EAST VILLAGE  
Preliminary Development Plan Phase 2  
Lots 14-22 & Tracts C, E-G  
Section 8, Township 47 North, Range 31 West  
LEE'S SUMMIT, JACKSON COUNTY, MISSOURI

Preliminary Development Plan

PRELIMINARY DEVELOPMENT PLAN  
Preliminary Development Plans for:  
East Village  
Lee's Summit, Jackson County, Missouri

SITE PLAN PHASE 2

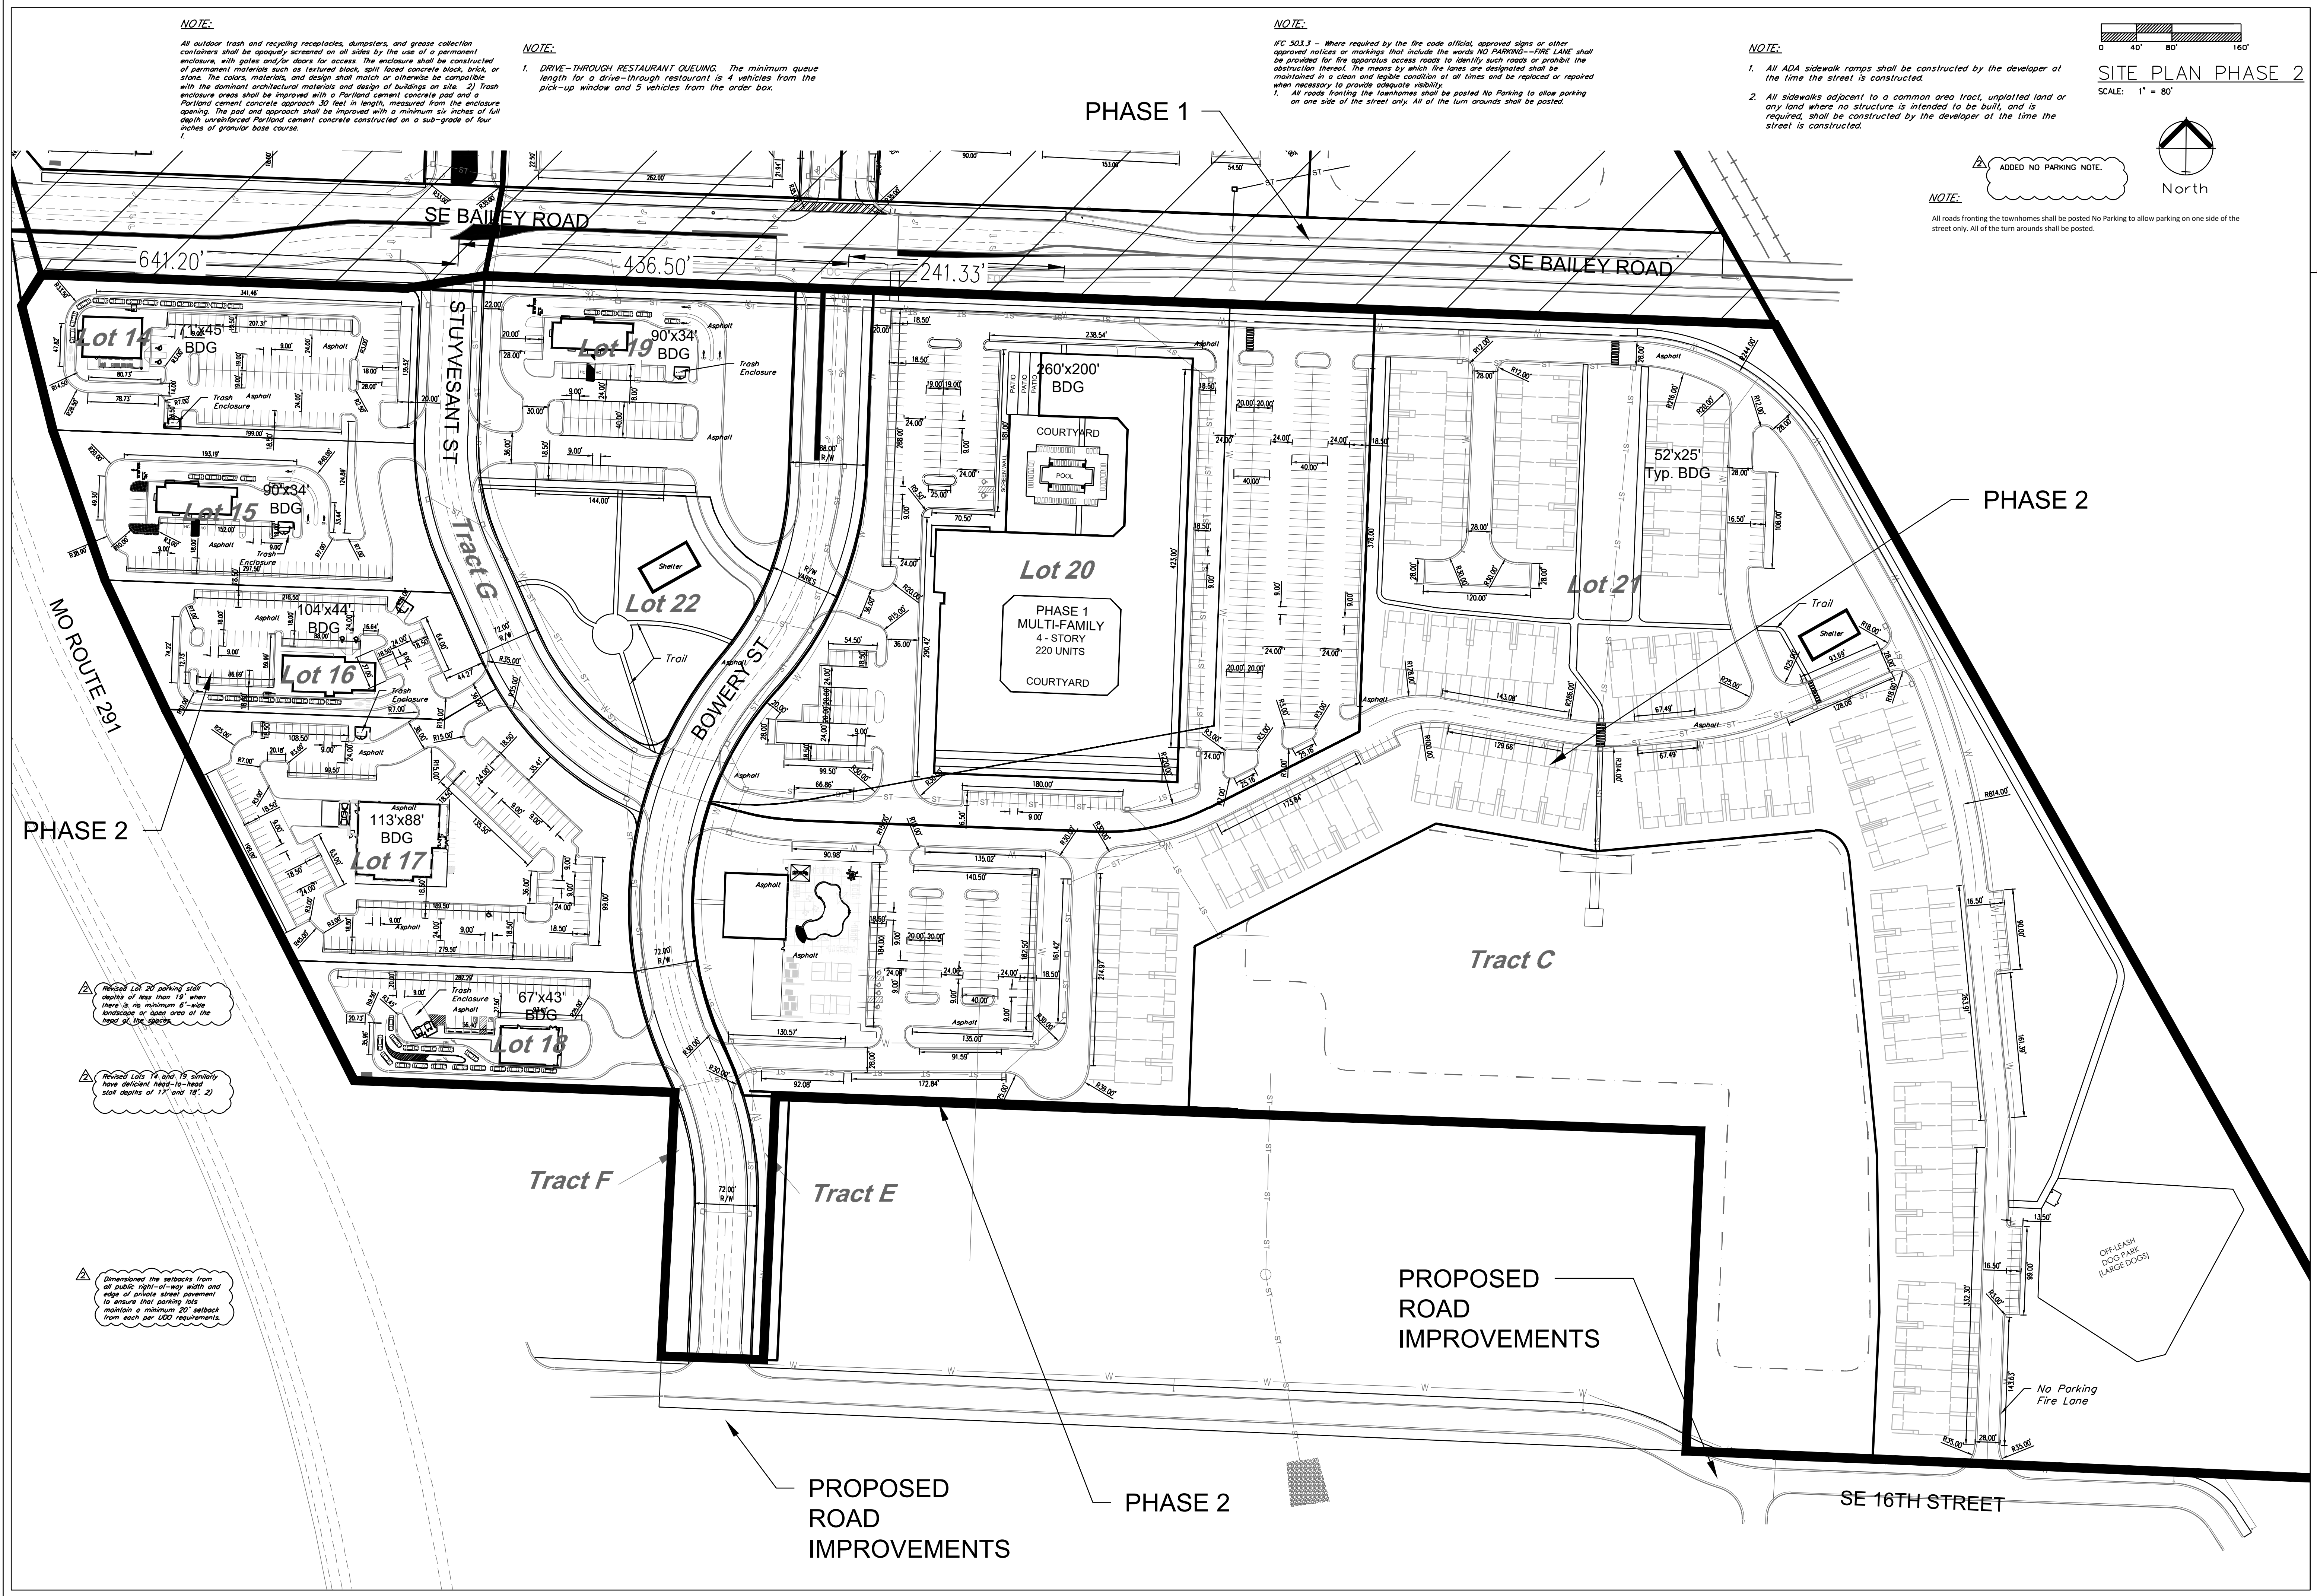
All roads fronting the townhomes shall be posted No Parking to allow parking on one side of the street only. All of the turn arounds shall be posted.

Revised Lot 20 parking stall depths of less than 12' when there is no minimum 6'-wide landscape or later area of the head of the street.

Revised Lots 14 and 16 similarly have deficient head-to-head stall depths of 17' and 16', 2).

Dimensioned the setbacks from all public right-of-way width and edge of private street pavement to ensure that parking lots maintain a minimum 20' setback from each per L&D requirements.

AMENITY PLAN  
Preliminary Development Plans for:  
East Village  
Lee's Summit, Jackson County, Missouri

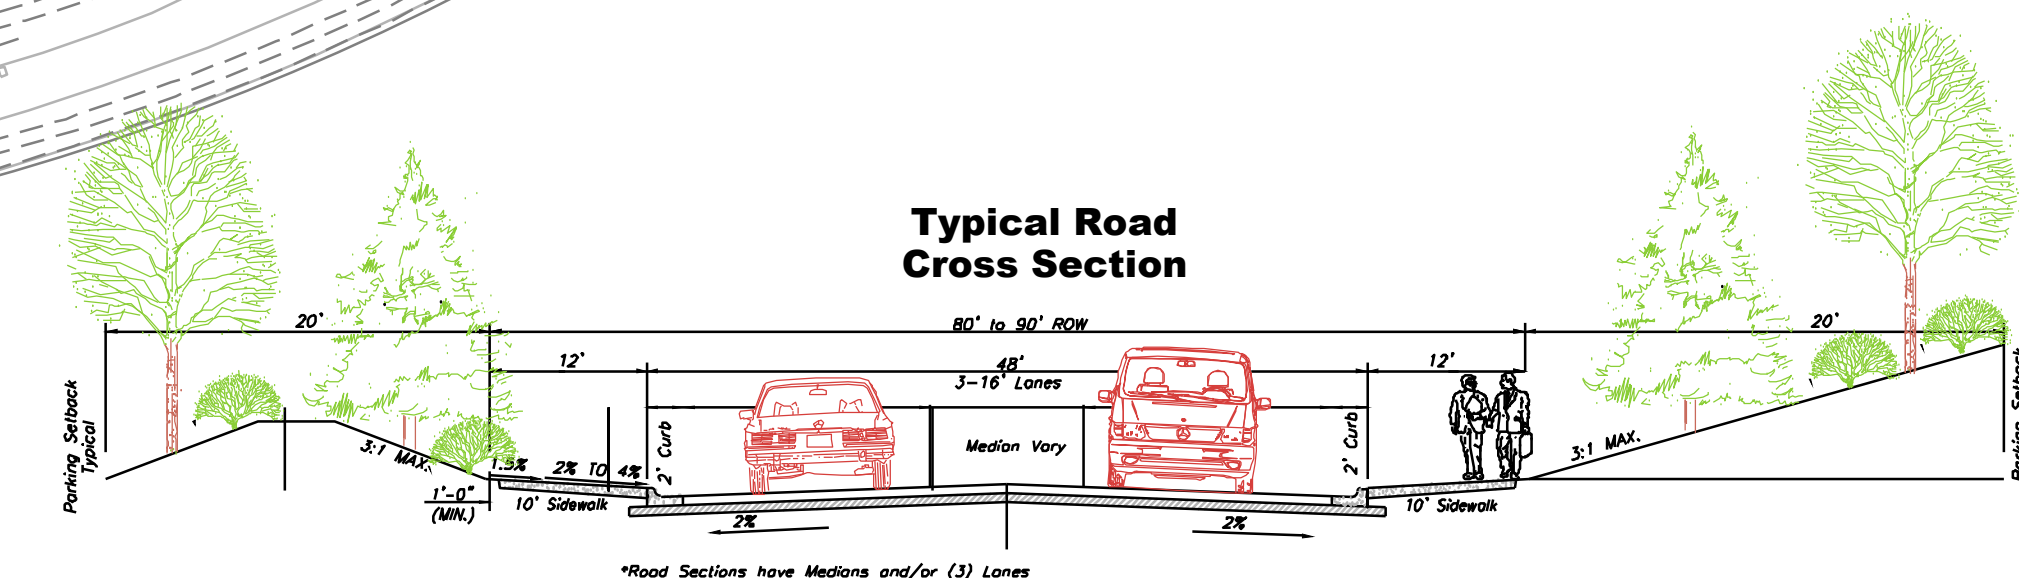
2 ADDED SHELTER LABELS TO LOTS 21 AND 22.

# OVERALL UTILITY PLAN

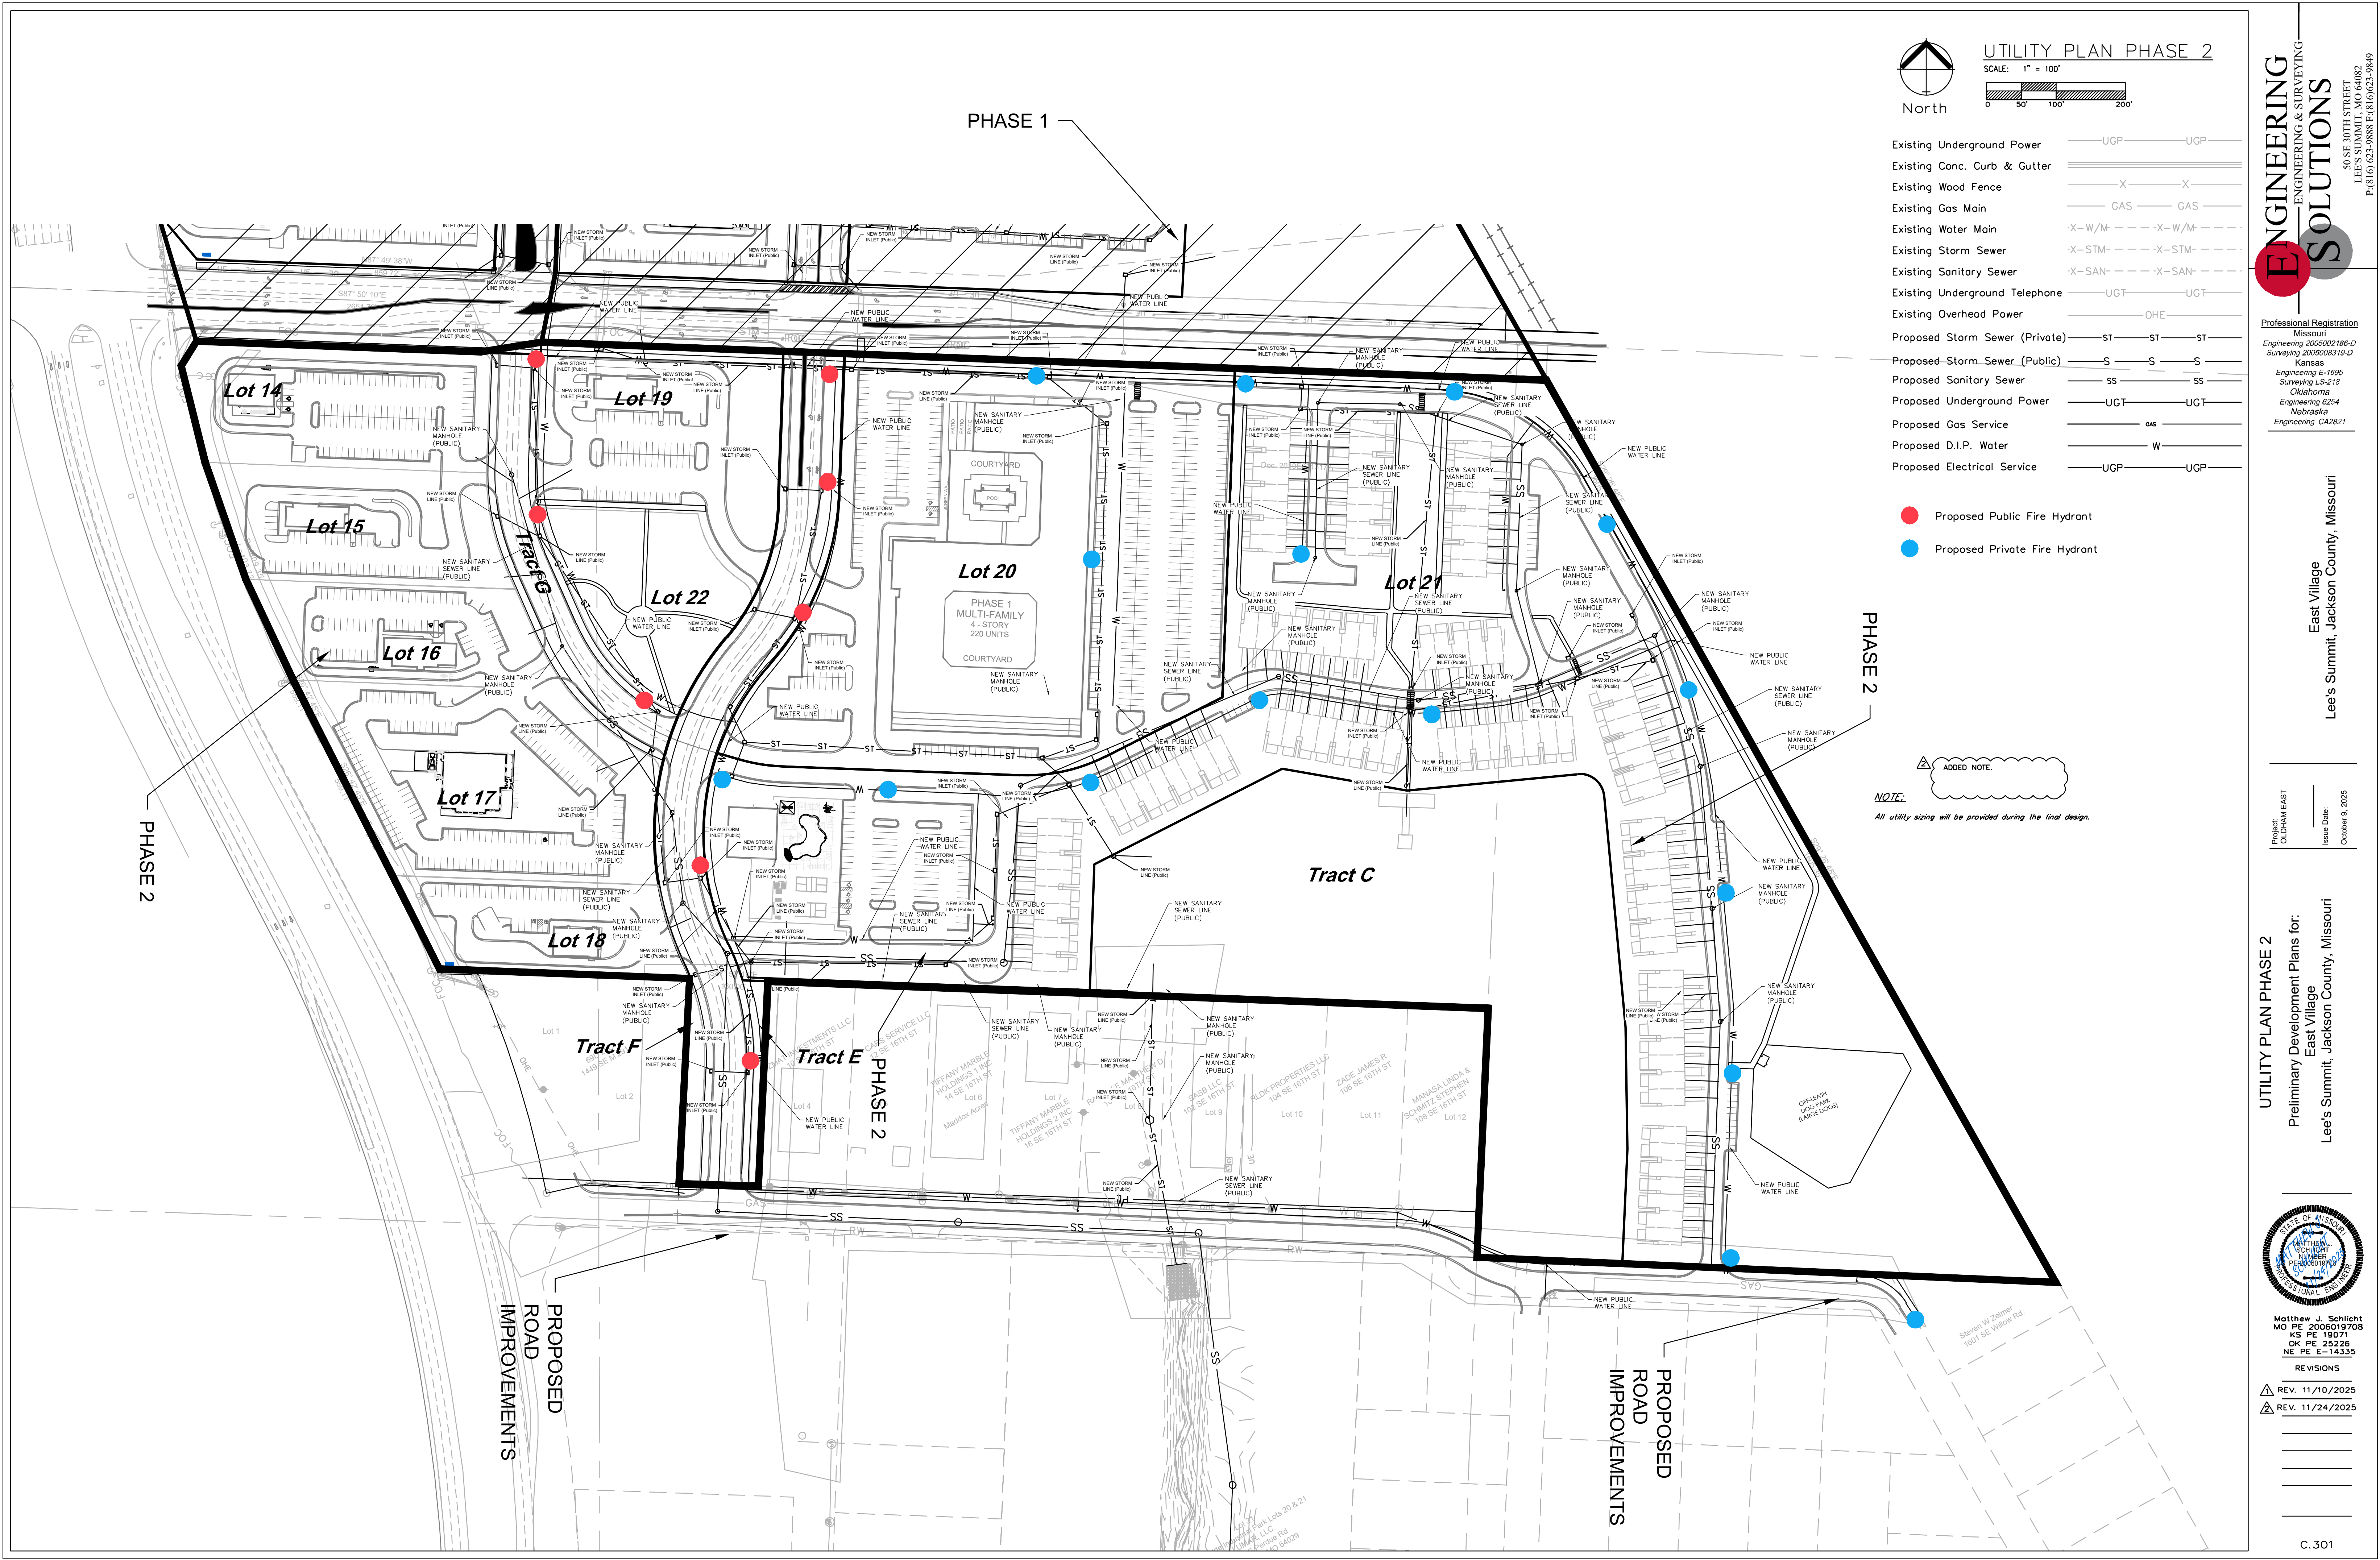
REMOVED LOT TO REMOVE  
POLLUTION

EXTENDED WATER LINE TO  
WILLOW ROAD

EXTENDED SANITARY LINE
